09 March 2026

Addendum 5

Beaufort EMS

Beaufort, NC

E3

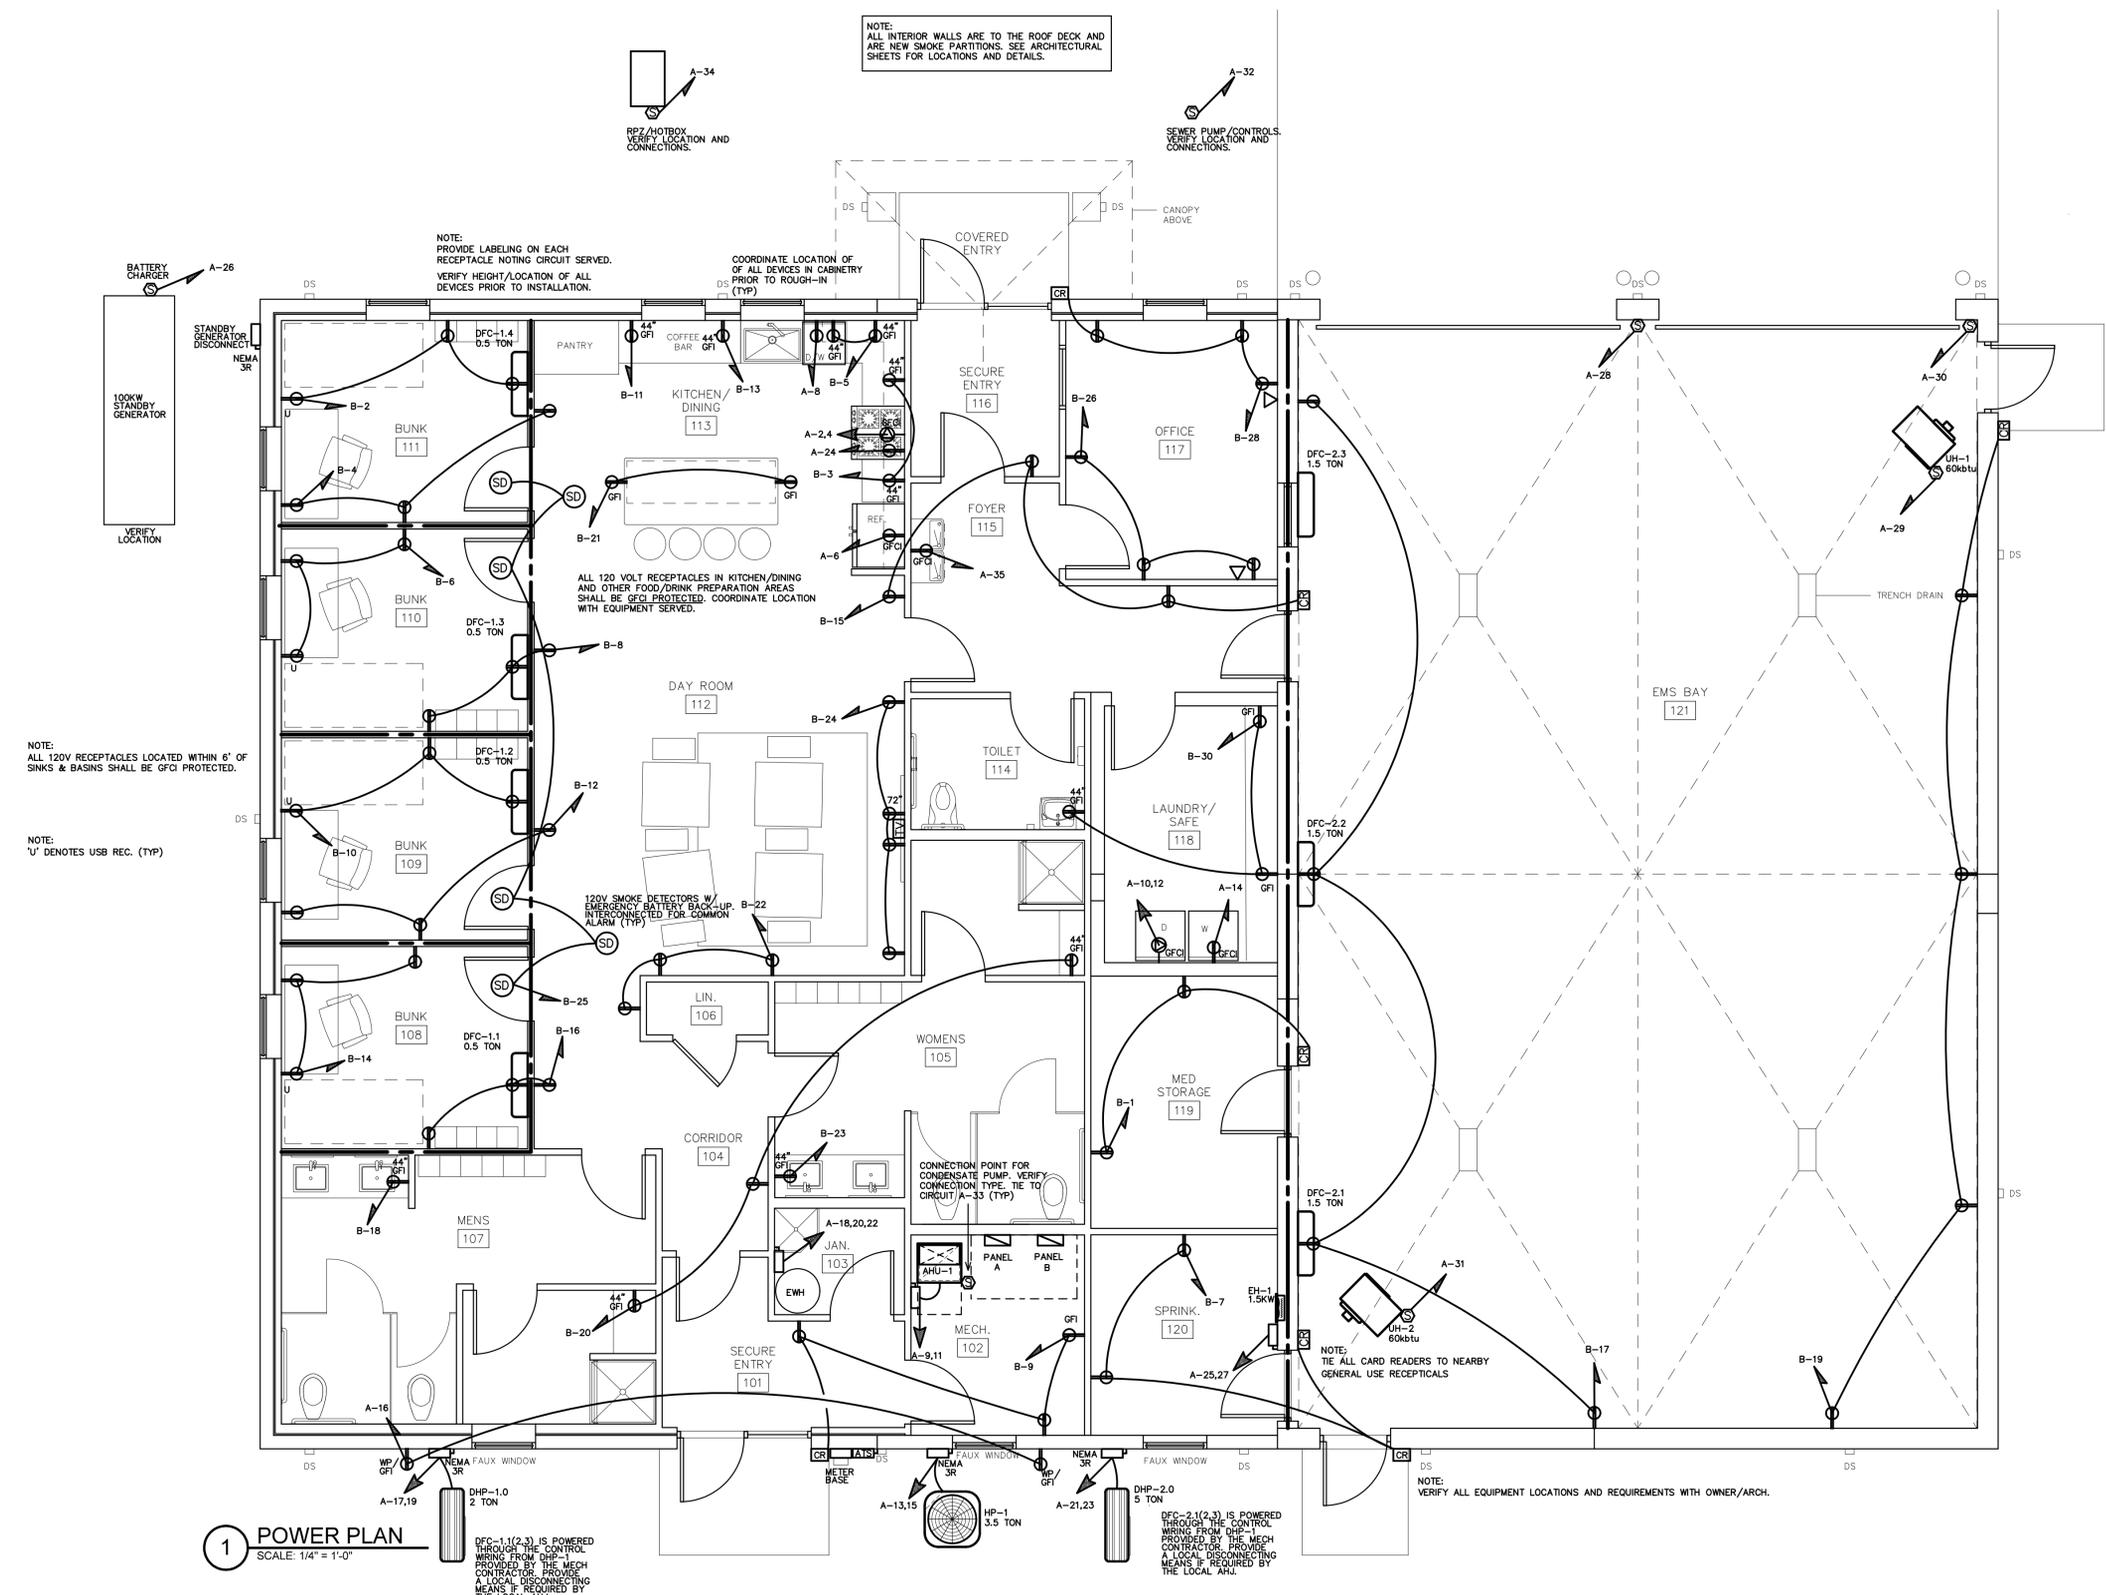
- See attached revised E3 and E4 for power requirements for STEP and RPZ hot box.
- Clarification, C401: Extend the 8" PVC shown to all downspouts around the building.
